## ADDENDUM 3

DATE: March 12, 2026

RE: Prairie du Chien Public Safety Building  
SEH No. PDCAR 177629

**1 FOUNDATION & FRAMING PLAN - LEVEL 1**  
1/16" = 1'-0"

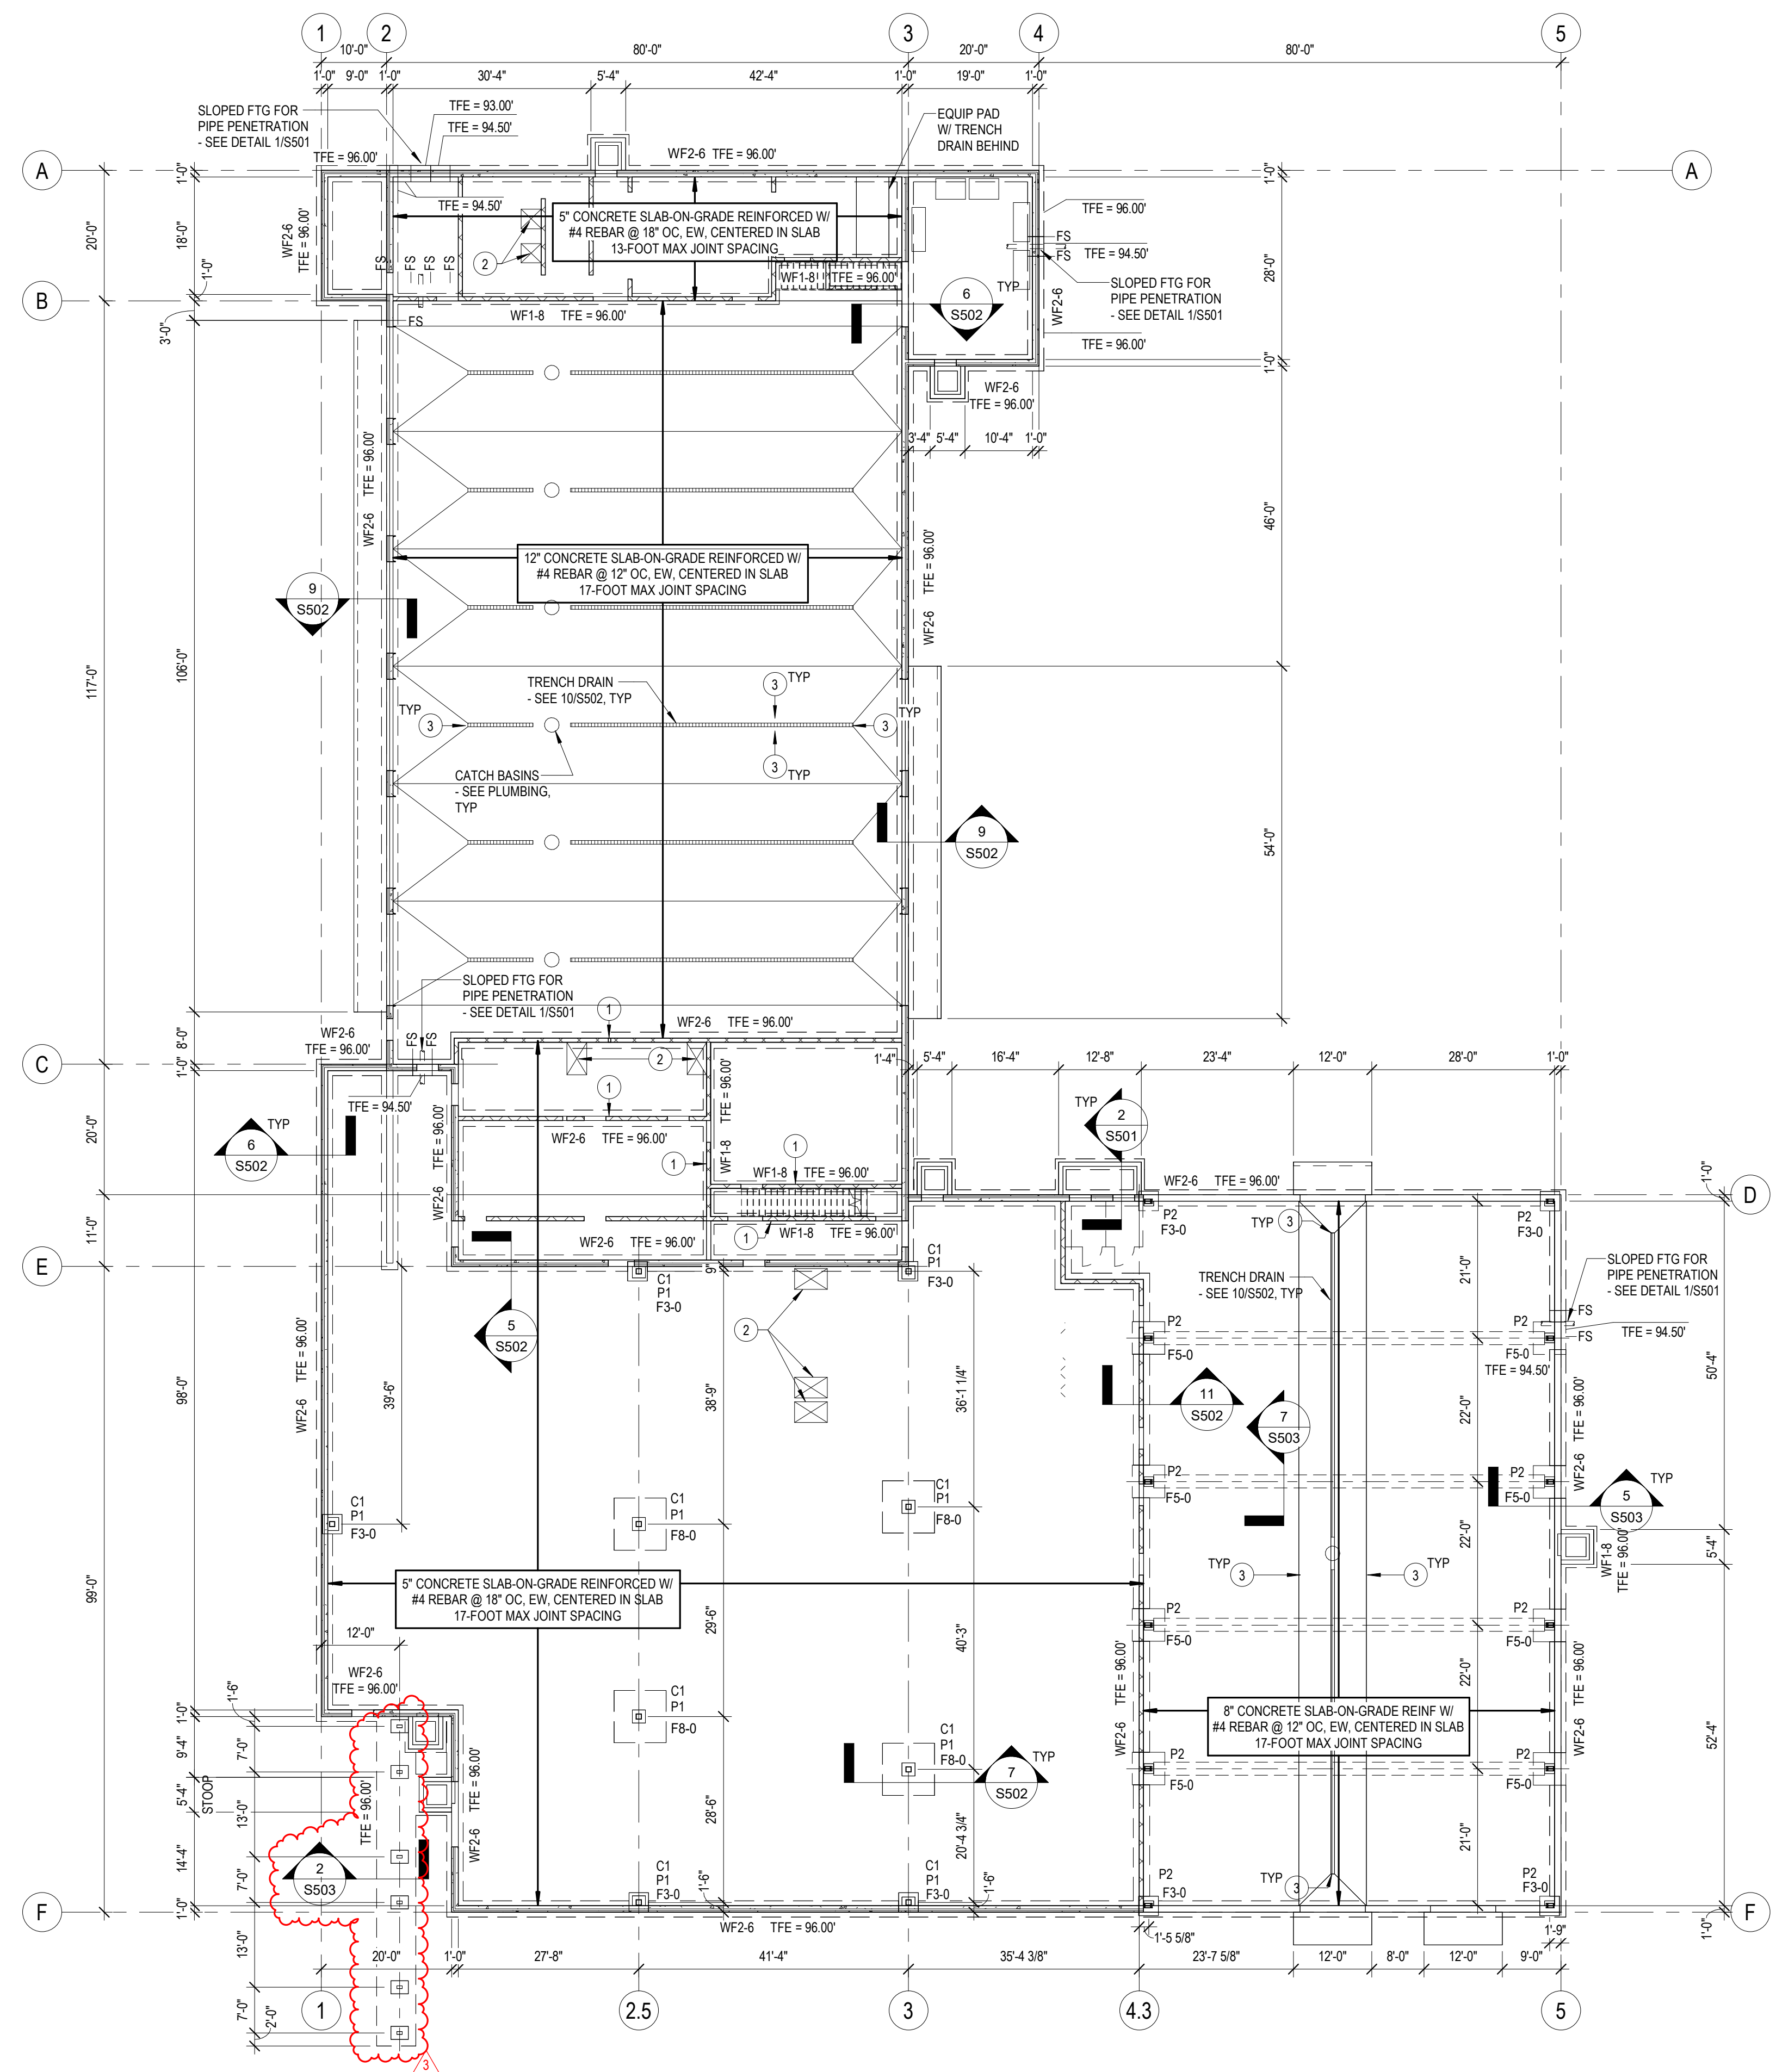
1. Sheet S111 (Attachment)
  - a. Canopy pier foundations modified.
2. Sheet S131 (Attachment)
  - a. Joist bearing elevations noted.
3. Sheet S401 (Attachment)
  - a. Housekeeping pad notes modified.
4. Sheet S503 (Attachment)
  - a. Foundation detail modified.
5. Sheet S513 (Attachment)
  - a. Detail notes modified.
6. Sheet S521 (Attachment)
  - a. Detail note modified.
